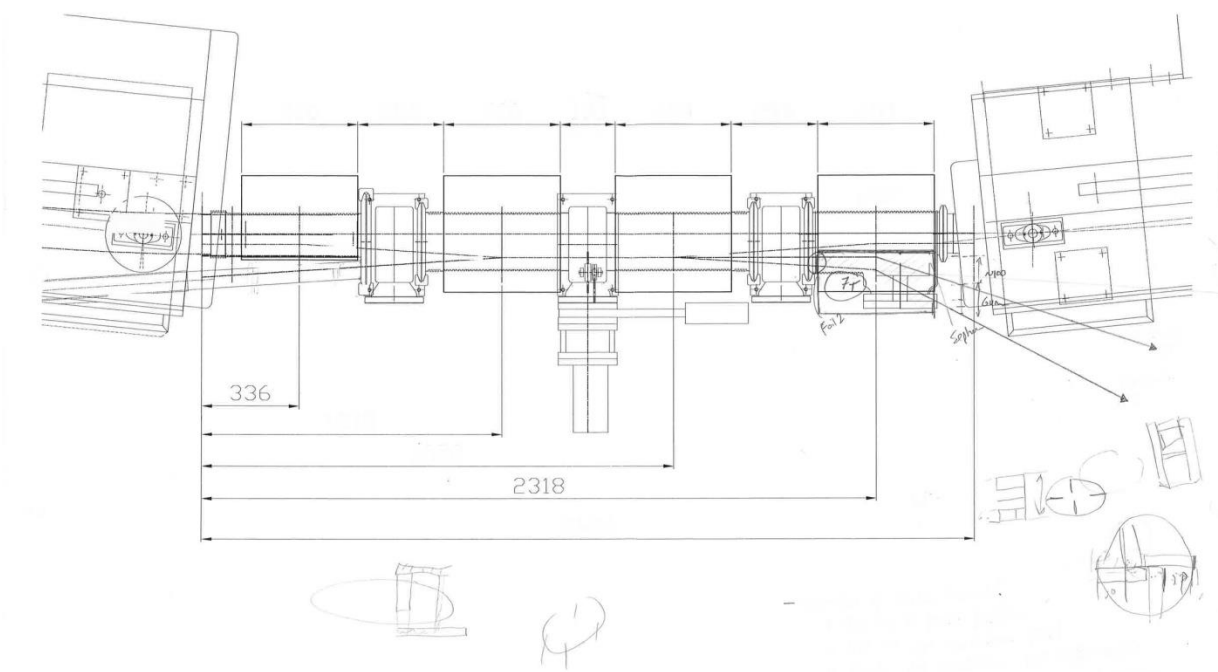
Best practices suggest to avoid combining multiple functions in one component whenever possible. In particular, it would be advisable to keep the dump design separated from that of the beam monitor.

- EN-STI to possibly revise the design (with BI), but may be difficult or impossible
